**Laboratory Environment Safety and Health Committee
Cryogenic Safety Subcommittee**

MINUTES OF MEETING 04-10

November 3, 2004

- 1. Review of the AGS Snake Magnet**

PARTS & SYSTEMS TO BE ANALYZED & PRESENTED FOR LATER REVIEW

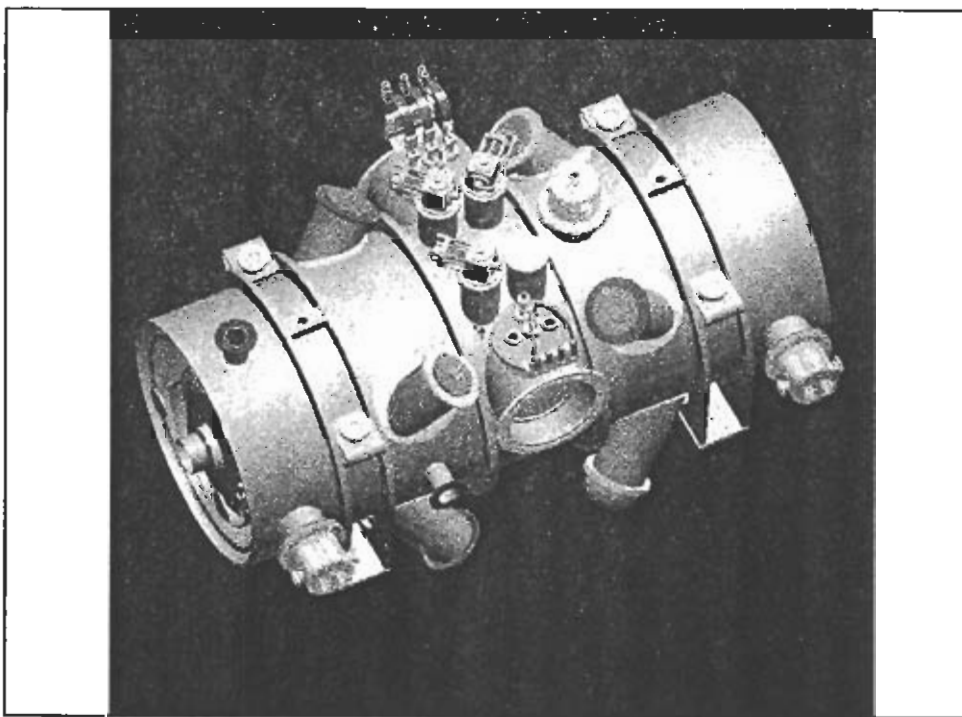
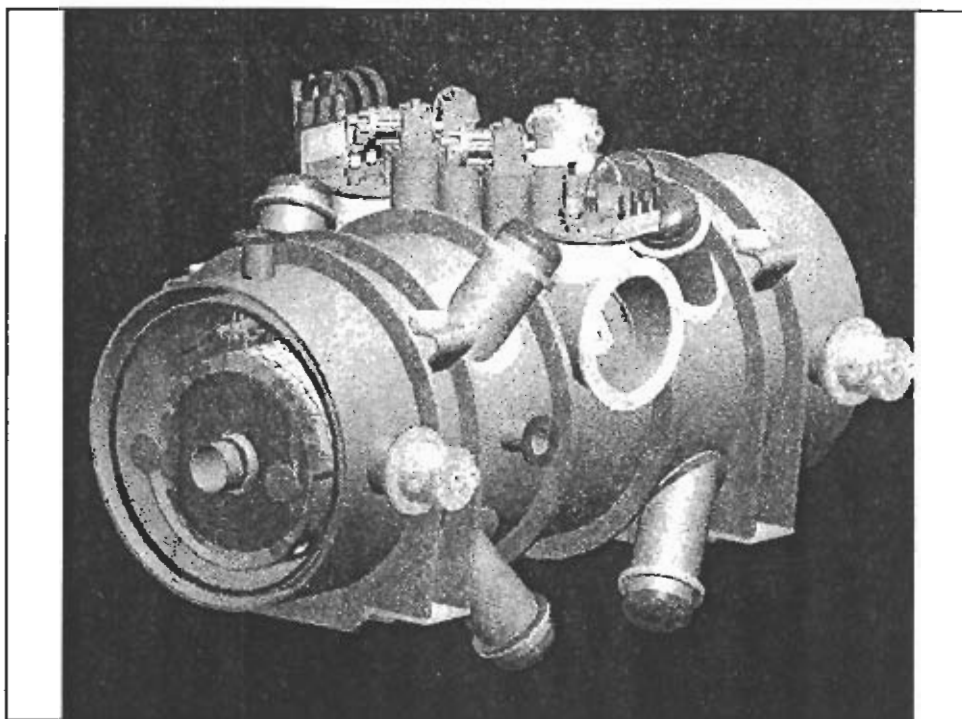
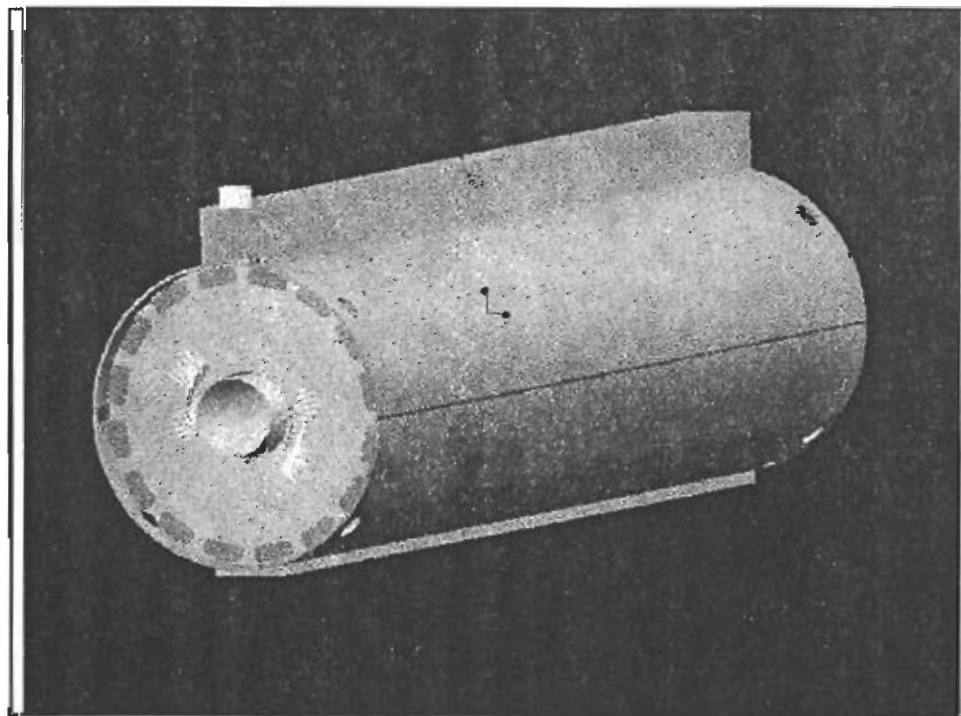
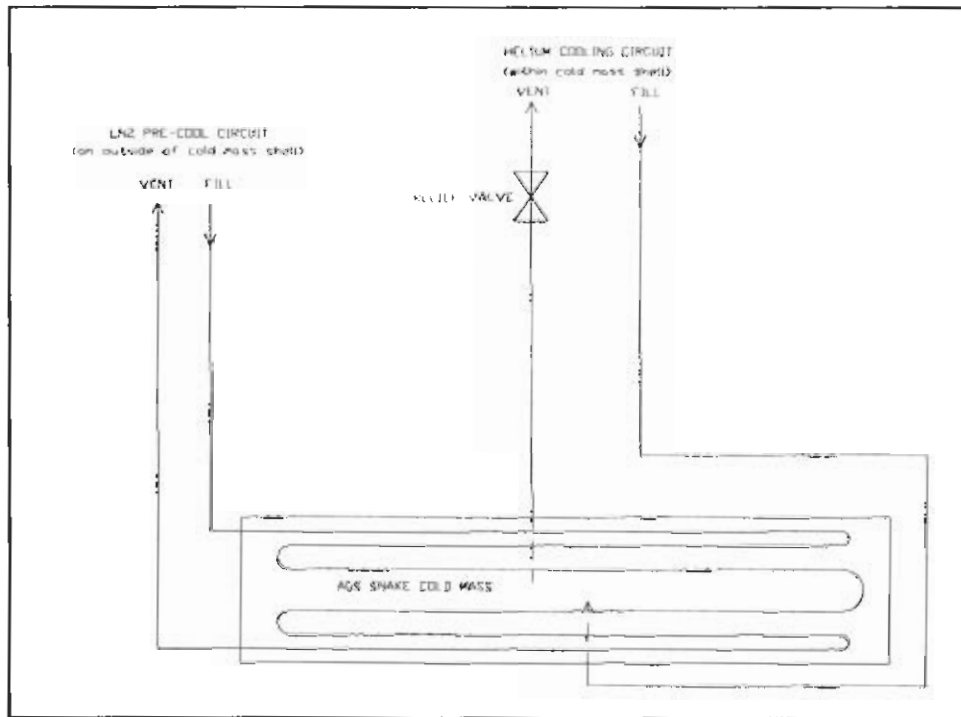
- In addition to the maximum pressure stated, the cold mass and vacuum vessel should be analyzed for full vacuum, and that pressure must be stated as a parameter as well.

- To clear the LN₂ circuits of nitrogen before cooling below 77K, they should be purged using nitrogen gas first, then pumped as required.
- The heat shield lines must have a stated pressure rating and accompanying relief valve added.

- The vacuum vessel must have a relief valve (NOTE: intended but not shown).
- The cold mass relief valve size must be based on either the volume of gas generated from a quench or the volume from a catastrophic loss of vacuum, whichever causes the more severe condition.
(ACTION: A. Sidi-Yekhlief to provide guideline of energy input to system based on vacuum loss)

- Acceptability of electrically operated solenoid valve vs. a passive spring-operated valve was questioned. Perhaps both are required.
(ACTION: CSS to provide guidance on this topic after discussion with members)

- A relief valve mounted above a bolted connection might not meet ASME Code requirements; must be checked. A precedent that would allow bolted flanges has perhaps been set via the design of the relief valves in the RHIC valve boxes.
(ACTION: CSS will provide its interpretation and ruling)

- The design of the cold mass pressure relief tube should be looked at further, especially regarding the temperature gradient along the tube and in the compensation bellows, and the effects of thermal convection of helium gas within the tube and outside the bellows should be studied further.
